Access Compliance Report

Public Rights-of-Way

(Curb Ramps)

Intersection ID: 53019	Main Street: BILLET_LN	Cross Street: CHARTRES_LN	Location: NE
ADA ID: 711171E4E046	Ramp Type: Perp	Initial Pass/Fail: Pass	Overall Compliance: No
Codes/Mitigation Info/Possible Solution		Field Measurements/Component Compliance	
		Severity Score: 10

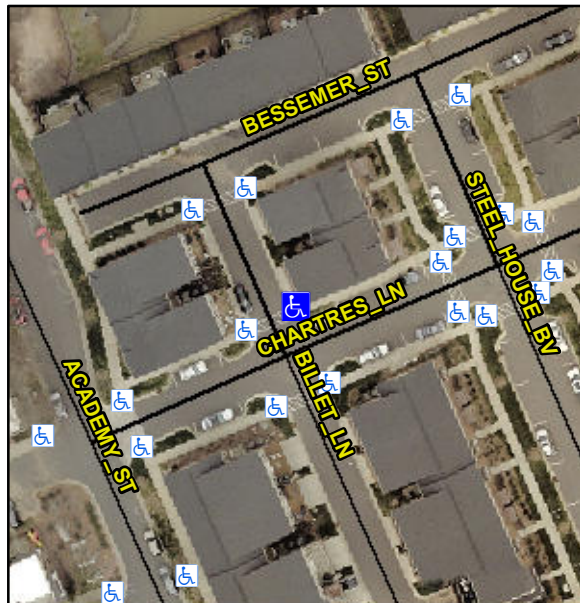
**Not Found, R305.1.4, R305.2,
R302.7.2, R304.5.3**

Compliance	Description	Data	Compliance	Description	Data
N/A	Ramp Length (in)	246.0	Yes	Ramp Slope (%)	5.8
Yes	Ramp Width (in)	60.0	Yes	Ramp XSlope (%)	0.3
N/A	Flare Type LT	None	N/A	Flare Type RT	N/A
N/A	Flare Slope LT (%)	N/A	N/A	Flare Slope RT (%)	N/A
N/A	Flare Traversable LT?	N/A	N/A	Flare Traversable RT?	N/A
Yes	Landing Length (in)	59.0	Yes	DWS Provided?	Yes
Yes	Landing Width (in)	60.0	Yes	DWS Contrast?	Yes
Yes	Landing Slope (%)	0.1	Yes	DWS Length (in)	24.0
Yes	Landing X Slope (%)	2.0	No	DWS Full Width?	No
N/A	Landing Curb? (Y/N)	No	No	DWS Offset (in)	9.0
N/A	Shared Landing?	No			
Yes	Gutter Ponding?	No	Yes	Gutter Slope (%)	0.5
No	Gutter Lip Ht (in)	0.5	No	Gutter X Slope (%)	3.0
N/A	Painted X Walk1?	Yes	N/A	Painted X Walk2?	N/A
	X Walk 1 Direction	To W		X Walk 2 Direction	N/A
N/A	X Walk 1 Width (in)	63.0	N/A	X Walk 2 Width (in)	N/A
	X Walk 1 Slope (%)	2.1		X Walk 2 Slope (%)	N/A
	X Walk 1 X Slope (%)	3.2		X Walk 2 X Slope (%)	N/A

Yes	Ramp inside XWalk1?	Yes	N/A	Ramp inside XWalk2?	N/A
	Road Slope (%)	N/A	N/A	Clear Space?	Yes
	Road X Slope (%)	N/A	N/A	Clear Space to XWalk (in)	N/A
Yes	Any Obstructions?	No	Yes	Storm Grate/Utility Hazard?	No
	Obstruction Type			Storm Grate/Utility Type	
		N/A			N/A
			Yes	Surface Condition? (G/P)	Good

**Remove & Replace Entire Ramp.
Remove & Replace Gutter.**
